SUNDRY NOTICES AND REPORTS ON WELLS
(DO NOT USE THIS FORM FOR PROPOSALS TO DRILL OR TO DEEPEN OR PLUG BACK TO A DIFFERENT RESERVOIR. USE "APPLICATION FOR PERMIT" (FORM C-101) FOR SUCH PROPOSALS.)
1. Type of Well: Oil Well [] Gas Well [] Other []
2. Name of Operator XTO Permian Operating, LLC
3. Address of Operator 6401 Holliday Hill Rd Bldg 5, Midland TX 79707
4. Well Location Unit Letter I : 1980 feet from the South line and 660 feet from the East line
Section 36 Township 22S Range 30E NMPM County Eddy
11. Elevation (Show whether DR, RKB, RT, GR, etc.) 3310.2 GR

Well Name: James Ranch Unit 037

JRU 037 - Proposed WBD

Action 291047

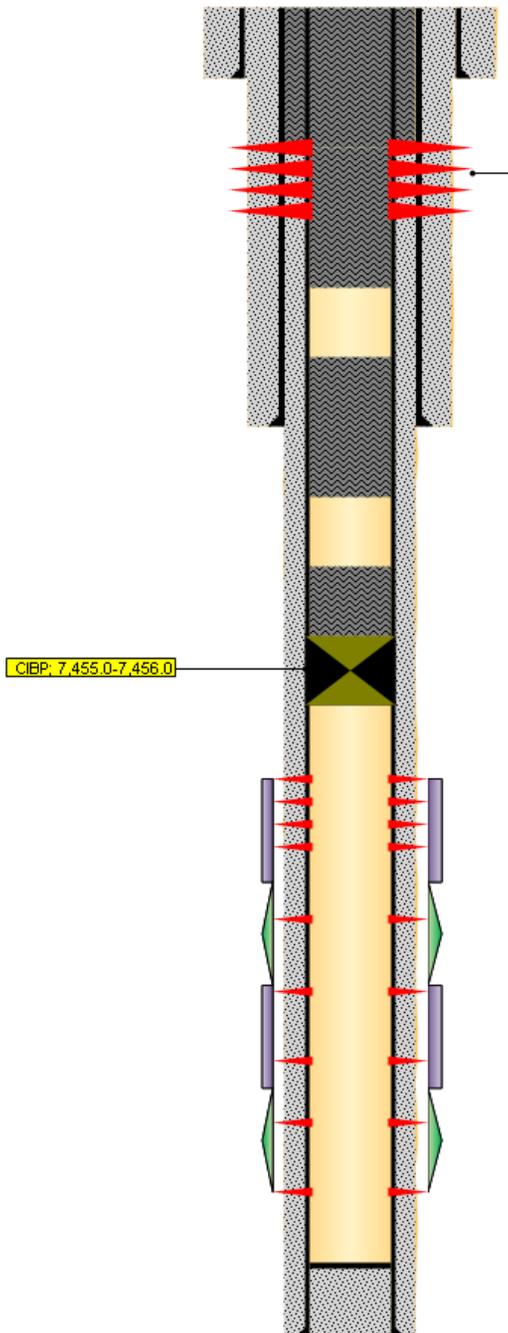
Set CIBP @ 7470' - Test Casing, run CBL and bubble test

Spot 25 sks cl C cmt @ 5018' - T Cherry Canyon

Solid cement plug from 3650' - Surface

SEE ATTACHED COA's MUST BE PLUGGED BY 11/1/24
